# Access Compliance Report

## Public Rights-of-Way

Intersection ID: 3625	Main Street: SANDRINGHAM_PL	Cross Street: CHOWNING_TAVERN_LN	Location:	N
ADA ID: 372AF29963AB	Ramp Type: Perp	Initial Pass/Fail: Fail	Overall Compliance: No	Severity Score: 33.75
Codes/Mitigation Info/Possible Solution		Field Measurements/Component Compliance

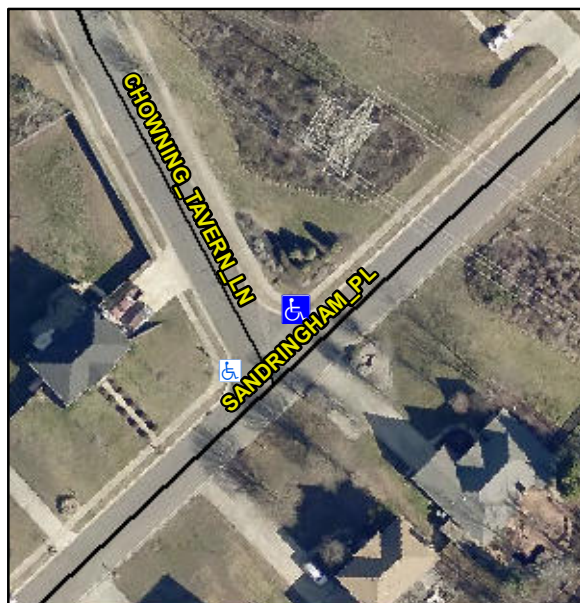
**Not Found, R304.5.1, R304.5.3**

Compliance	Description	Data	Compliance	Description	Data
N/A	Ramp Length (in)	71.0	Yes	Ramp Slope (%)	5.1
No	Ramp Width (in)	36.0	No	Ramp XSlope (%)	7.8
N/A	Flare Type LT	N/A	N/A	Flare Type RT	N/A
N/A	Flare Slope LT (%)	N/A	N/A	Flare Slope RT (%)	N/A
N/A	Flare Traversable LT?	N/A	N/A	Flare Traversable RT?	N/A
N/A	Landing Length (in)	N/A	N/A	DWS Provided?	N/A
N/A	Landing Width (in)	N/A	N/A	DWS Contrast?	N/A
N/A	Landing Slope (%)	N/A	N/A	DWS Length (in)	N/A
N/A	Landing X Slope (%)	N/A	N/A	DWS Full Width?	N/A
N/A	Landing Curb? (Y/N)	N/A	N/A	DWS Offset (in)	N/A
N/A	Shared Landing?	N/A			
N/A	Gutter Ponding?	N/A	N/A	Gutter Slope (%)	N/A
N/A	Gutter Lip Ht (in)	N/A	N/A	Gutter X Slope (%)	N/A
N/A	Painted X Walk1?	No	N/A	Painted X Walk2?	N/A
	X Walk 1 Direction	To SW		X Walk 2 Direction	N/A
N/A	X Walk 1 Width (in)	N/A	N/A	X Walk 2 Width (in)	N/A
	X Walk 1 Slope (%)	10.2		X Walk 2 Slope (%)	N/A
	X Walk 1 X Slope (%)	2.2		X Walk 2 X Slope (%)	N/A

**Remove & Replace Entire Ramp.**
